NEWMAR CORPORATION

TECHNICAL SERVICE BULLETIN

480

Spartan Motors USA, Inc. has decided that a condition exists where the power steering pumps may be equipped with an incorrectly sized orifice. Spartan Motors USA, Inc. made the decision to issue a Campaign Service Bulletin, **CSB17-260-001**, for certain 2017 model year K2 motor home chassis built between August 22, 2016, and October 5, 2016. In response, Newmar Corporation is publishing TSB 480.

FIG. 2-1

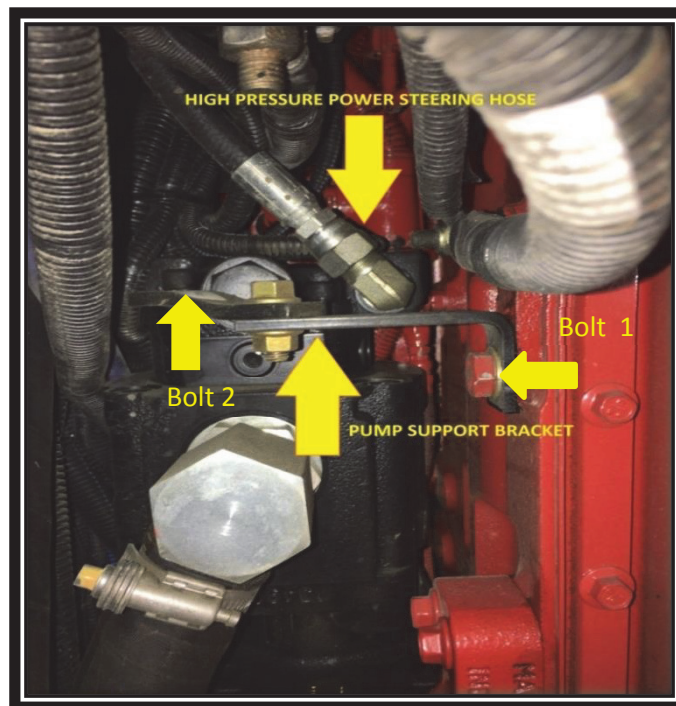
1. Remove the power steering pump support bracket from the pump & the engine block by removing bolts 1 & 2, allowing access to the hex head cover as viewed from bottom. Retain for re-use. Refer to FIG. 2-1

FIG. 3-1

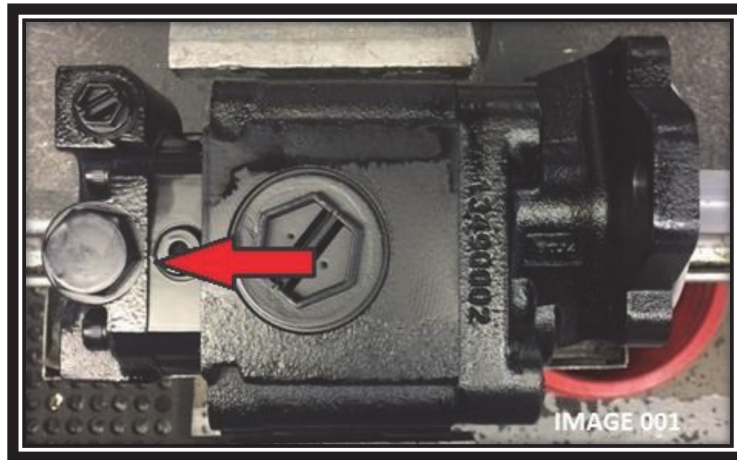
2. Clean lower surface areas on pump with any available degreasing product to ensure that the pump is not susceptible to contamination once opened.
3. Install the 30mm socket on the hex head cover and remove the cover shown. NOTE: The cover will be under a slight spring pressure. Refer to FIG. 3-1.

FIG. 3-2

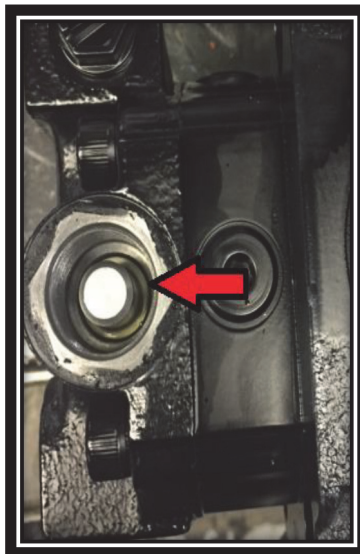
4. Once the cover is removed you will have exposed both the spool and spring. Remove the spring and place in a clean, dry location. Retain for re-use. NOTE: Some oil will drain from this location upon removal of the cap. Be prepared as the spool may slide out on its' own due to gravity. Refer to FIG. 3-2.

FIG. 4-1

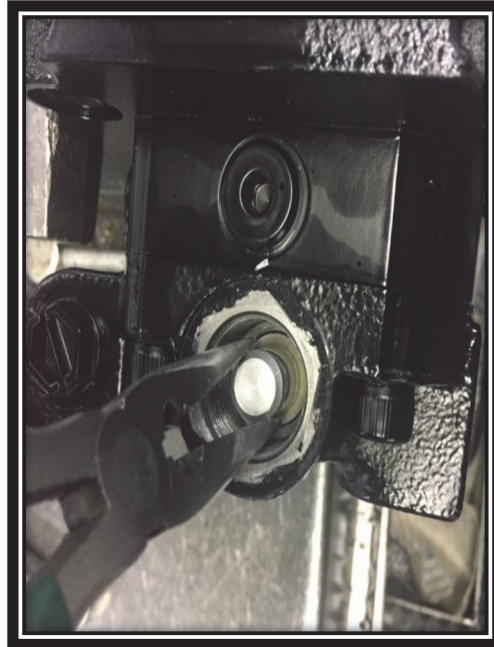
5. Once the spring is removed, use the Needle Nose Pliers to remove the spool shown. **NOTE: It is important to reference that the position of the spool is with the orifice facing away from you.** Refer to FIG. 4-1.

FIG. 4-2

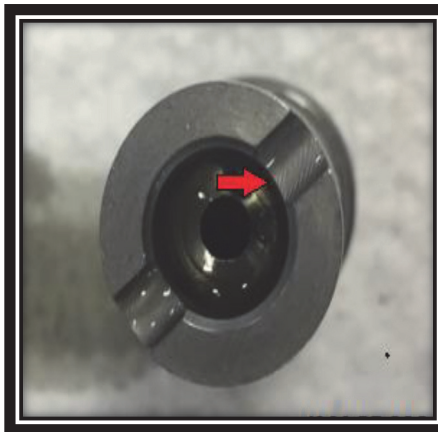
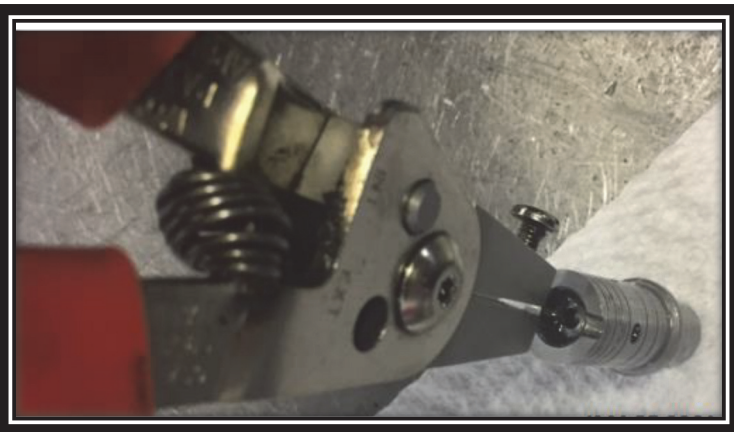
6. Re-install retained hex head cover to minimize oil loss. This can be hand tightened.
7. Once the spool is removed, flip it over to expose the snap ring. Using the snap ring pliers remove the snap ring. Refer to FIG. 4-2 and FIG. 4-3.

FIG. 6-1

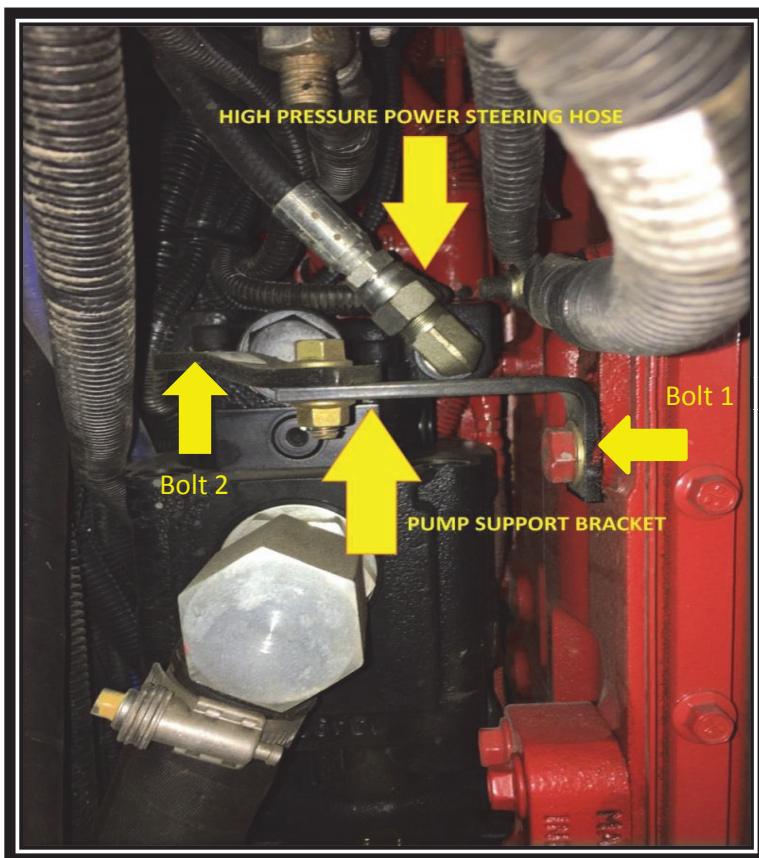
8. With the snap ring removed, tap spool against palm of your hand to remove orifice disc. Note orientation of orifice in spool. Once removed, properly dispose of original orifice disc.
9. Remove certified orifice disc from packaging and install into the spool. Ensure that orientation is as per the original orifice disc.
10. Insert snap ring into the groove on the inside of the spool locking the orifice disc in place.
NOTE: Use the snap ring pliers to spin the snap ring to ensure it is properly seated within the groove.
11. Remove hex head cover and insert spool into pump ensuring orifice disc is pointing away from you.
12. Replace the spring over top of the spool.
13. Reinstall hex head cover and torque to 90 NM (66.4 lbf-ft). Refer to FIG. 6-1.
14. Re-install retained pump support bracket to following specifications.

- Bolt #1 – Tighten to 47 lbf- ft torque with **Loctite® 242®**.
- Bolt #2 – Tighten to 52 lbf- ft torque.
